AGENDA
PLANNING AND ZONING COMMISSION MEETING
CITY OF CREVE COEUR, MISSOURI
MONDAY, MARCH 31, 2014
7:00 PM

**APPLICATION TO PLANNING AND ZONING COMMISSION
#14-005 APPROVAL OF AN AMENDMENT TO THE CONDITIONAL USE
PERMIT FOR BUFFALO WILD WINGS TO ALLOW SUBSTANTIVE
CHANGES TO THE EXTERIOR ELEVATIONS**

sheet title
EXTERIOR ELEVATIONS

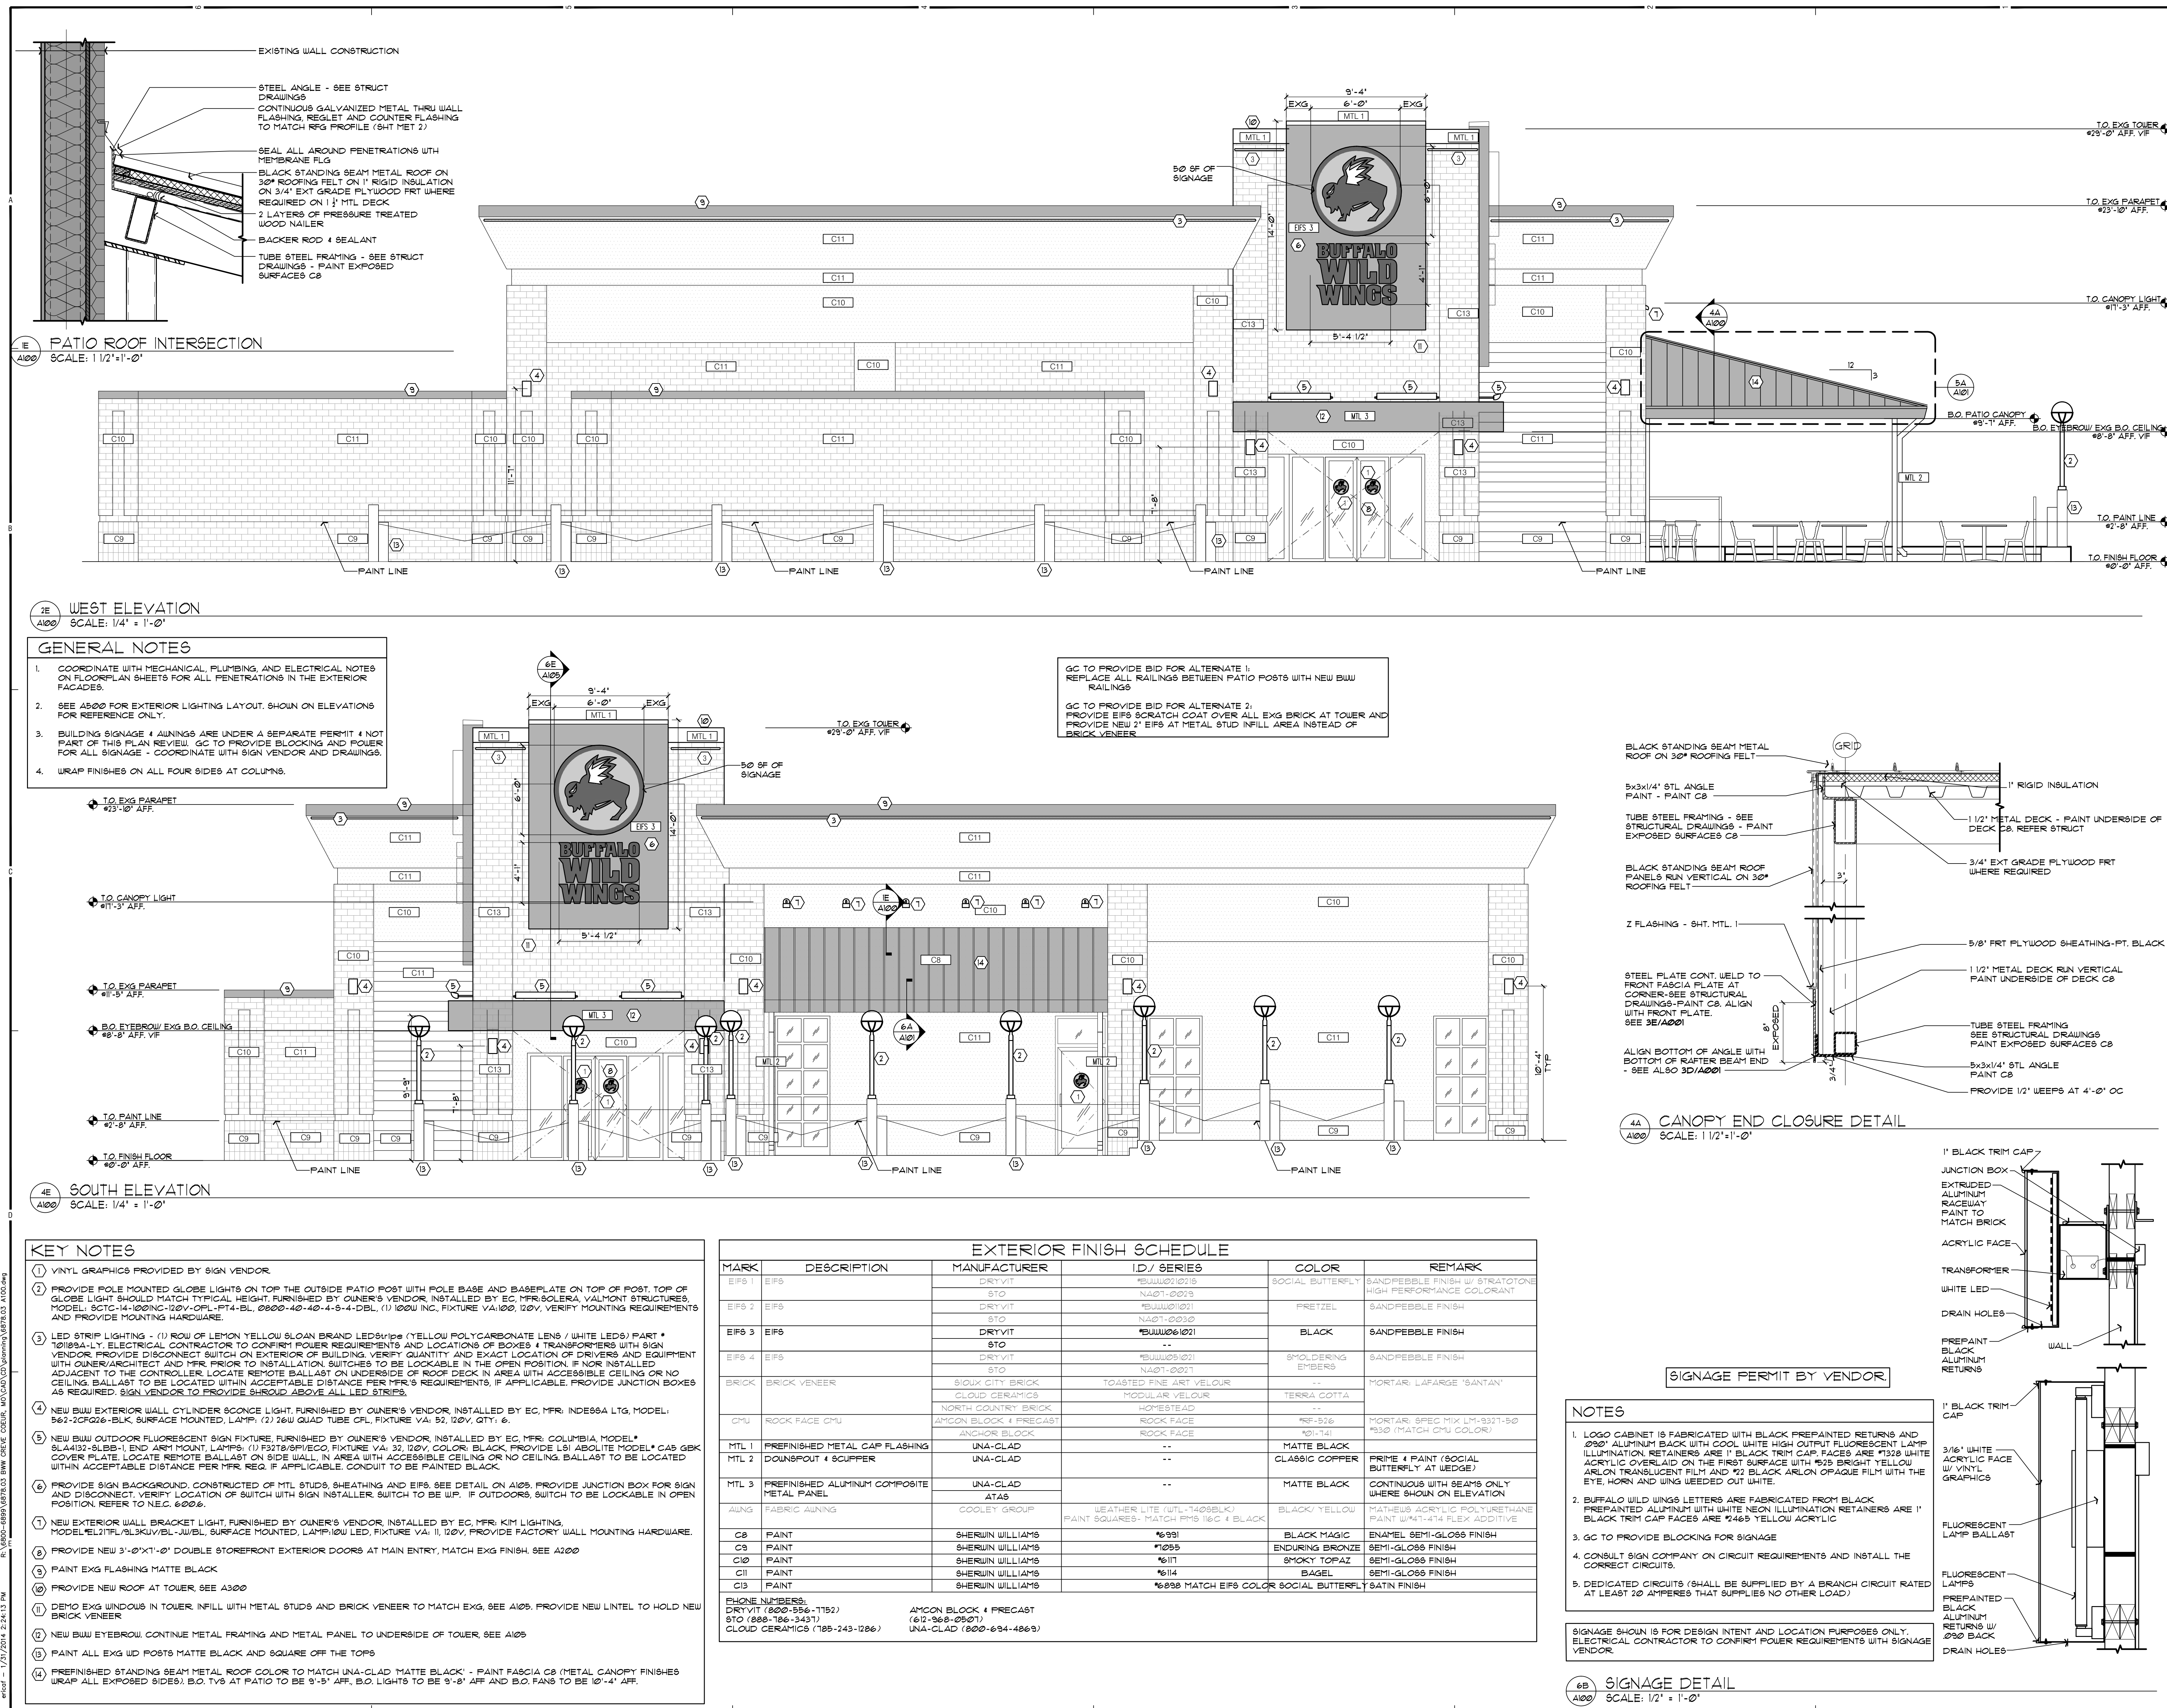
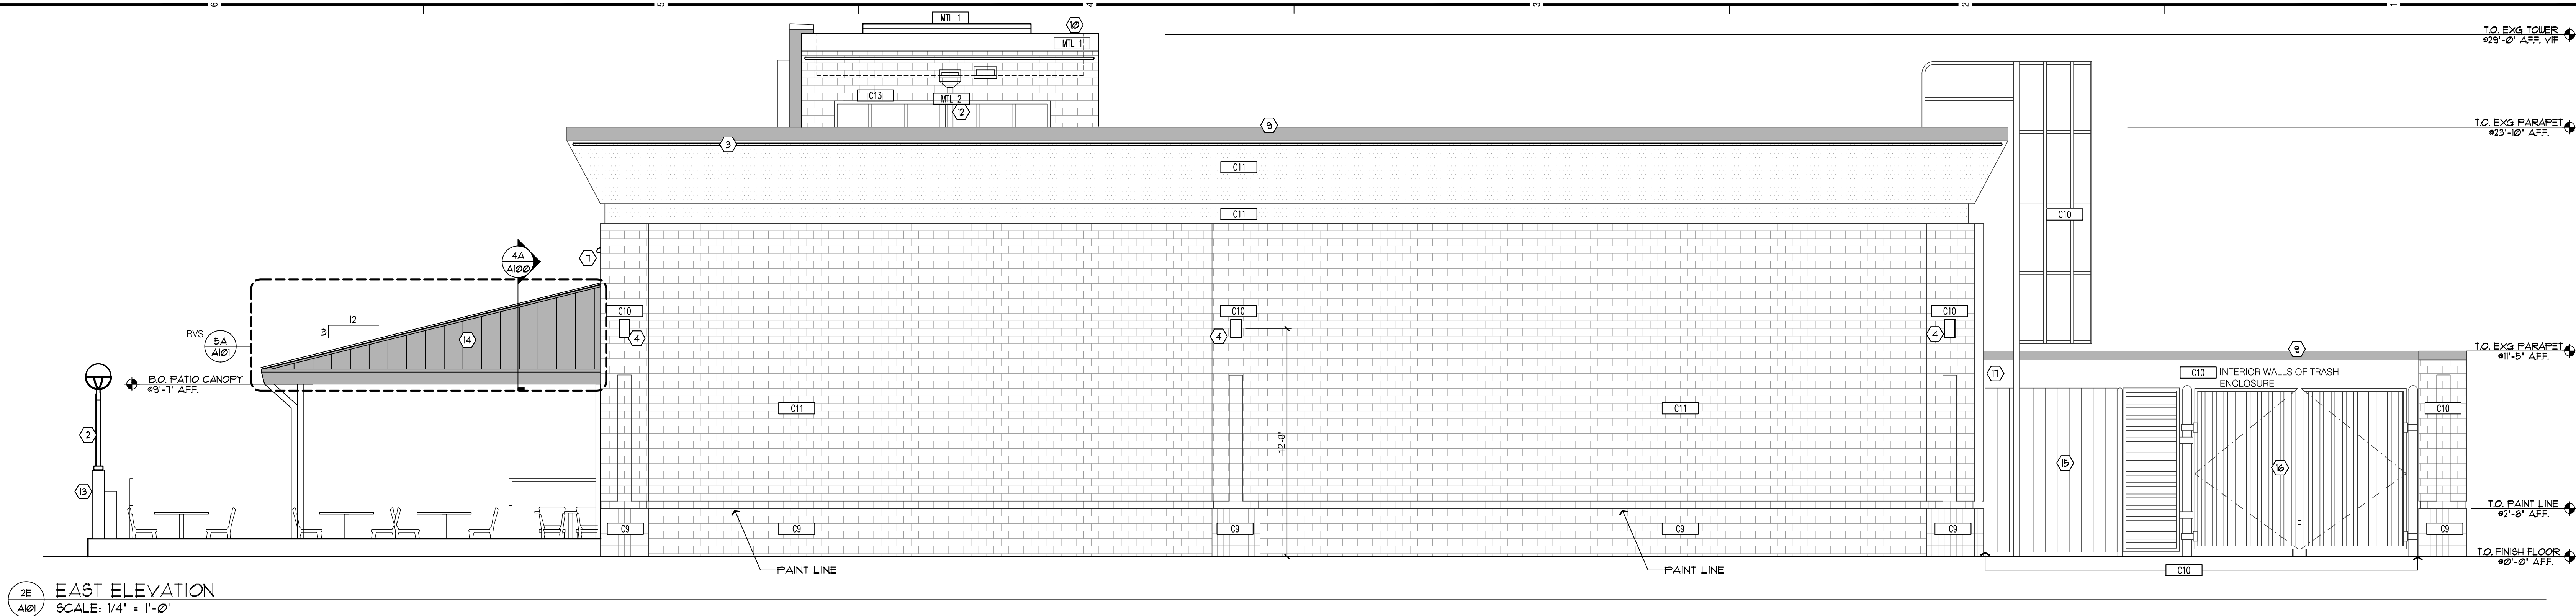
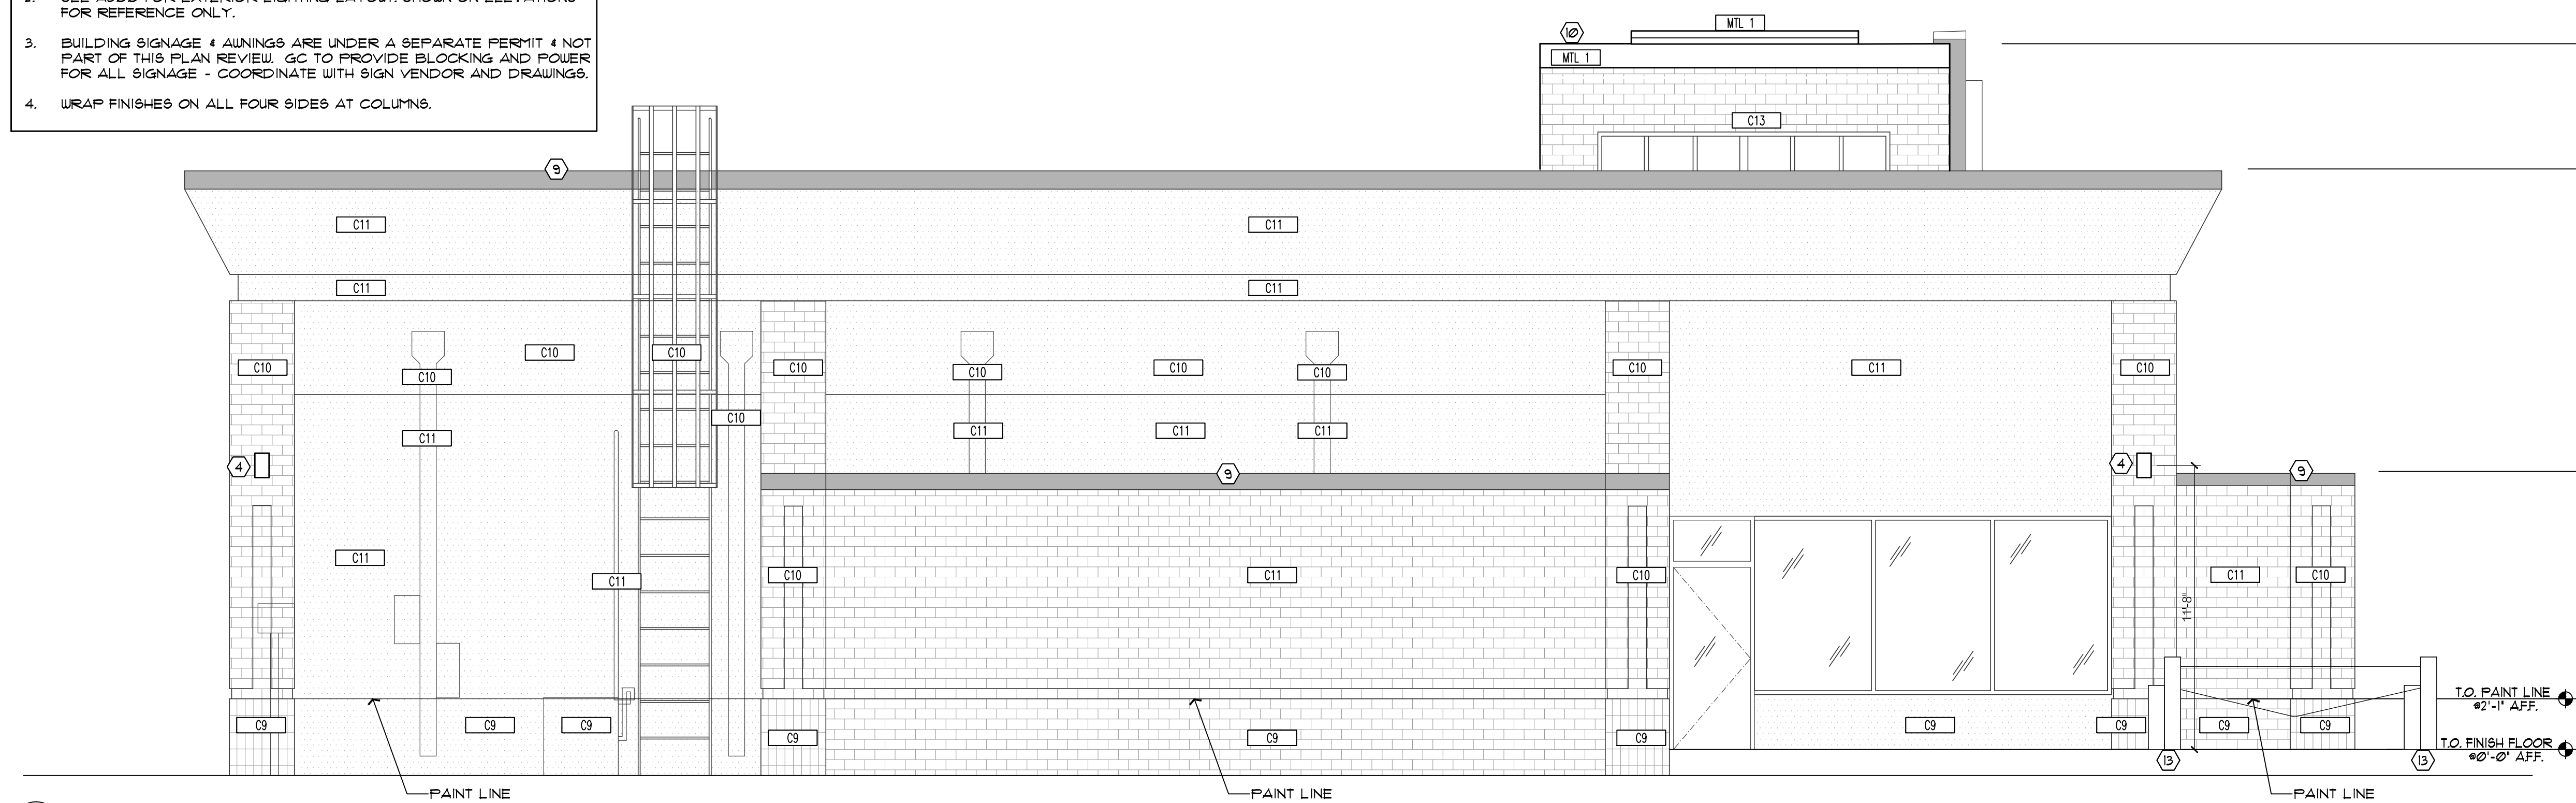
The Planning Commission should note that two sets of elevations have been received, one on February 4, 2014 and the second (electronically) on March 19, 2014. The drawings were changed as follows:

1. Removed 2 globe lights for the patio.
2. Removed the LED strip light on the back elevation of the building
3. Lowered the top of the new patio canopy so it aligns with the reveal line next to it on the building
4. Added an opaque strip on the top side of the LED lights to prevent light from shining up instead of adding a metal shroud on the building over those lights to block it.

The large awning placed over the patio does make the outdoor space more usable and the lower pitch shown in the revised drawings makes it less visually dominating over the front of the store. The use of standing seam aluminum is also appropriate under the Design Guidelines.

The design includes a yellow neon band (LED lighting is actually used although the visual impact is similar) along the top of the building walls, just below the parapet cap. Given that improving the night-time appearance of the building is desirable to both the tenant and the City, and as long as the band continues all the way around the building to help distribute the design elements around all sides, staff believe that this is an appropriate use of the device and should be approved by the Planning Commission as allowed under Section 405.930.F.7 of the Sign Code. It should be noted, however, that although the original proposal did continue the neon band all the way around the building, the revised concept received on March 19th eliminates the band on the rear of the building. A condition of approval should be that the band be kept on all four sides for the reasons discussed above. The use of an opaque strip instead of a metal cap on the LED strip and the removal of two of the globe lights do not appear to have a significant impact on the overall concept.

The last element of review under the Design Guidelines is the corner tower. The applicant proposes to paint it to match their corporate yellow and black scheme, to remove the decorative roof element and cover the existing glazing with large black panels that have new signs attached to them. New up-lighting below the sign panels are also included. This portion of the proposal is clearly not conforming to the goal that discourages the use of corporate architecture and it results in the loss of most of the few windows that the building has. It does further accentuate the location of the entrance and, overall, the building has a somewhat striking appearance, but it is clearly a particular corporate architectural theme and this raises concerns vis-à-vis the Design Guidelines.

The draft ordinance contains a condition of approval that stipulates to the second alternative above since it represents a compromise position. If the Planning Commission members wish to pursue other solutions, they should identify design priorities and provide the operator and staff time to work toward a solution.
